**DEPARTMENT OF TRANSPORTATION
STATE OF GEORGIA**

DeKalb & Fulton Counties
GDOT District 7 - Metro Atlanta
SR 42 Bicycle & Pedestrian Improvements,
From CS 1795/Mansfield Ave. to CS 3694/
DeKalb Ave.

SUBJECT APPROVED CONCEPT REPORT

**DEPARTMENT OF TRANSPORTATION
STATE OF GEORGIA
LIMITED SCOPE PROJECT CONCEPT REPORT**

SR 42/Moreland Ave - Proposed 5-lane w/bike lanes

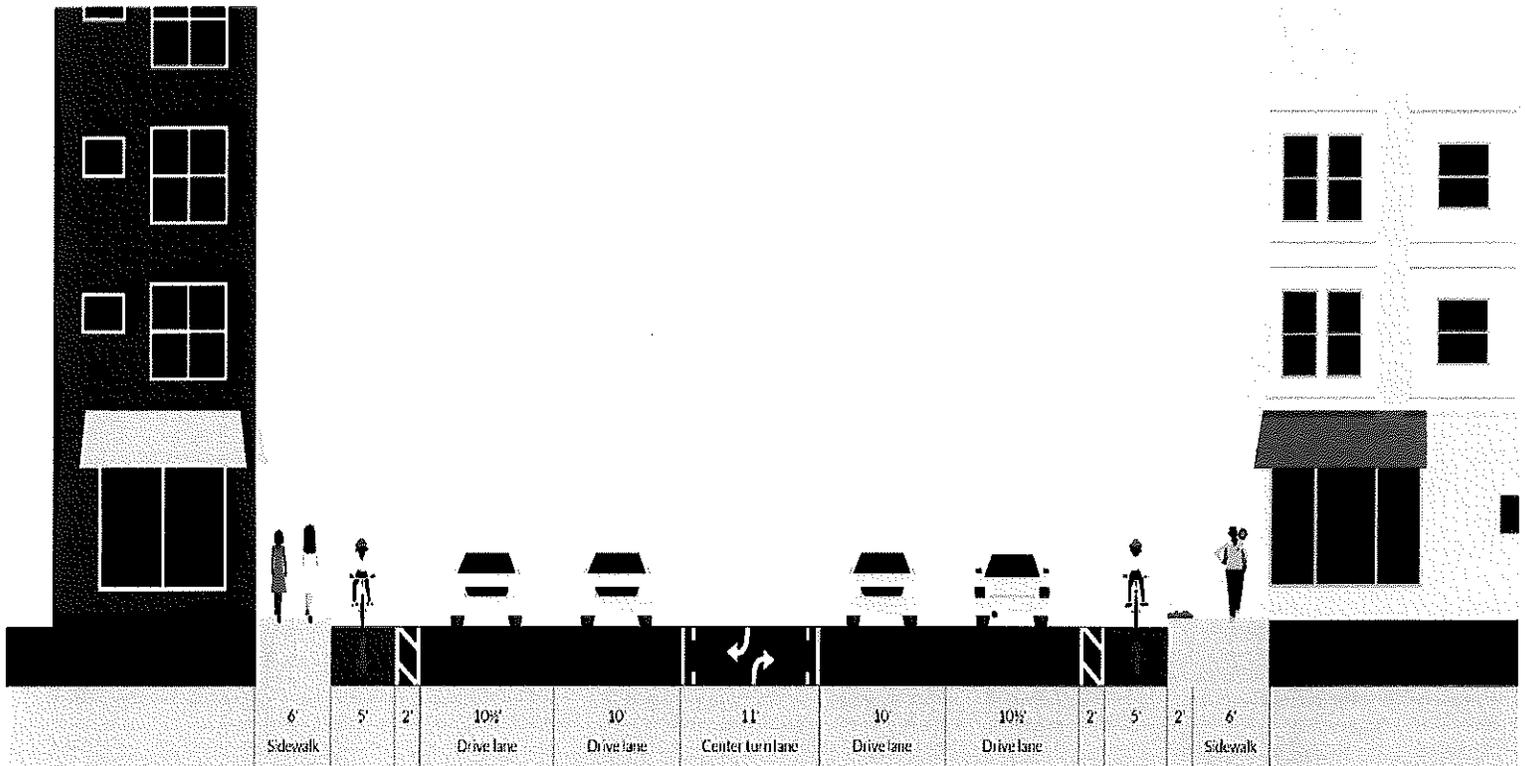
- We have the same concerns with the narrowing of the travel lanes as the Design Policy group does, given the accident data for sideswipes in the TE study, speed design, and traffic volumes. We recommend reducing or eliminating the 2ft travel lane-bicycle lane buffer to keep the travel lanes at or near 11 feet. *See response above.*

SR 42 / MORELAND AVENUE SAFETY & OPERATIONAL IMPROVEMENTS

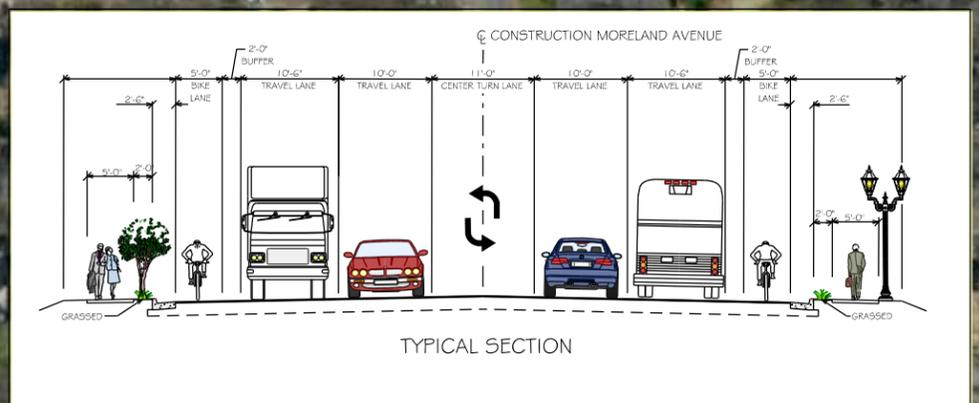
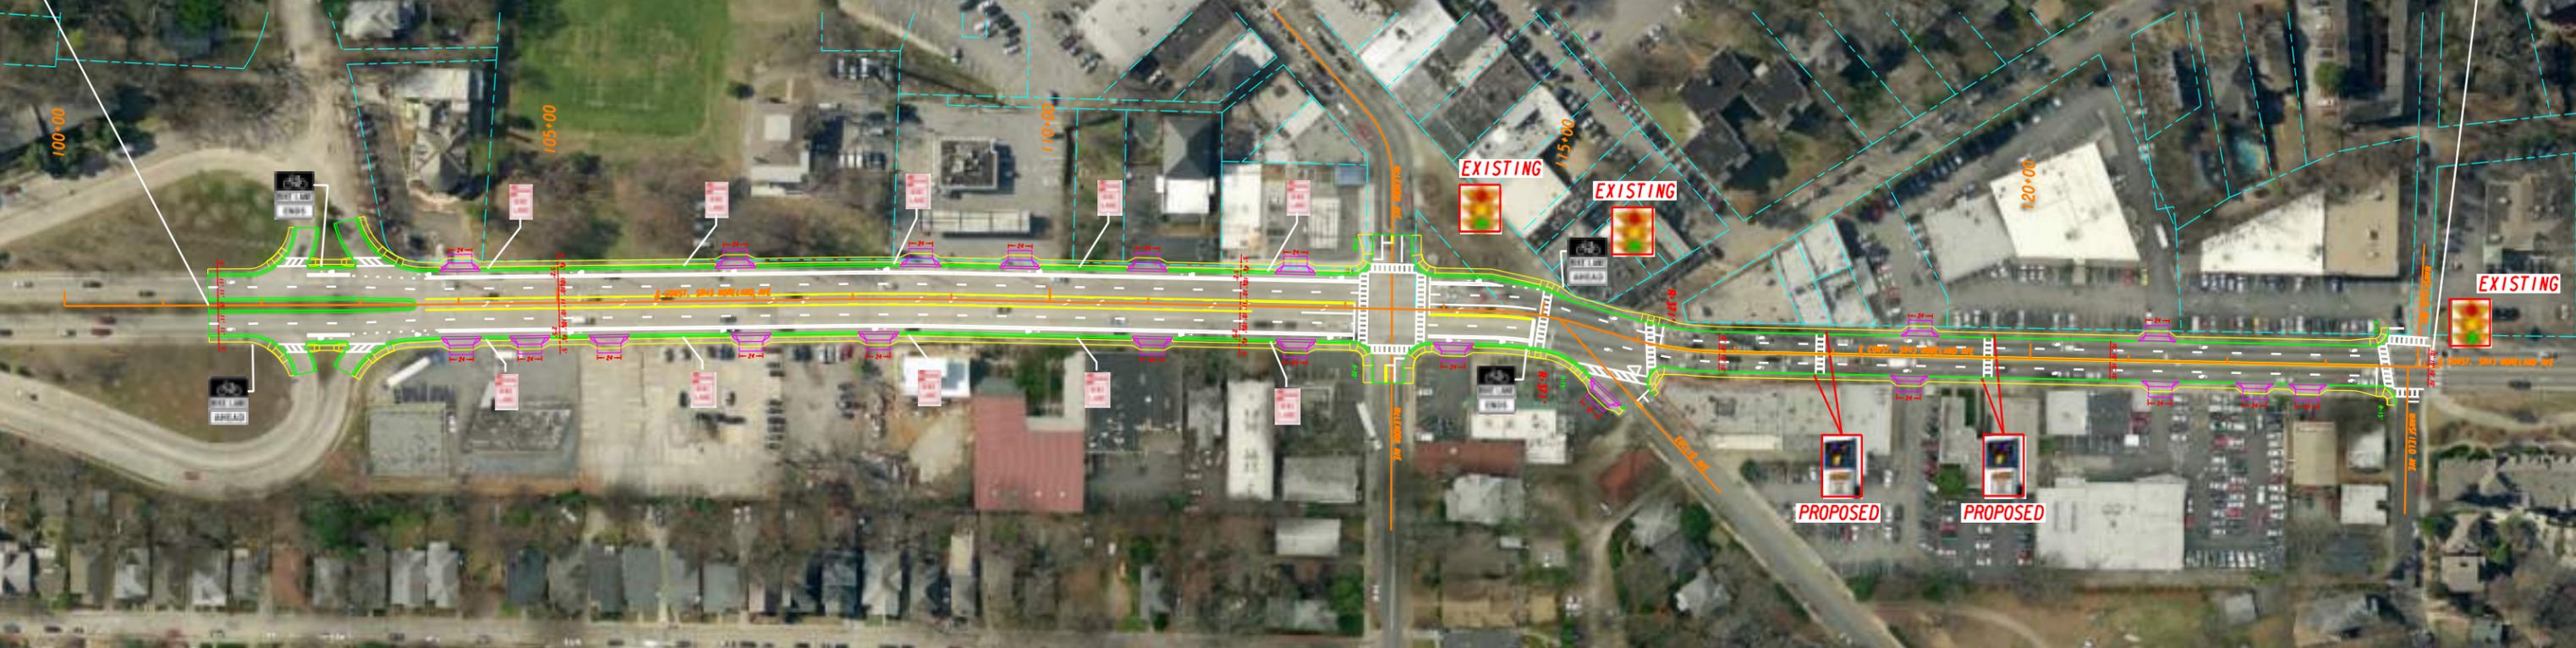
- As currently shown, the HAWK signal is show approximately 50 ft from access driveways to the south and 150 ft from access driveways to the north. The HAWK Signal can be relocated to split the distances to approximately 100 ft to the driveways.

- A suggestion by the CID was to move the header curbs on both sides towards the centerline to provide bike lanes with no striped buffer.
- Another suggestion by the CID was to provide planters, decorative boulders, or delineator posts in the bike buffer. It was also suggested to eliminate buffer area to provide an area for planters along the existing curb line.

- The CID questions the need and functionality of the new proposed southern most crosswalk shown across Moreland Ave at the intersection with Euclid Ave NE. This crosswalk can be removed so that the signal operations are not hampered by an additional movement.

- According to GDOT, the 2 ft painted buffers between the vehicle travel lane and the bike lane will be provided with no vertical separation such as the planters, boulders or delineator posts.
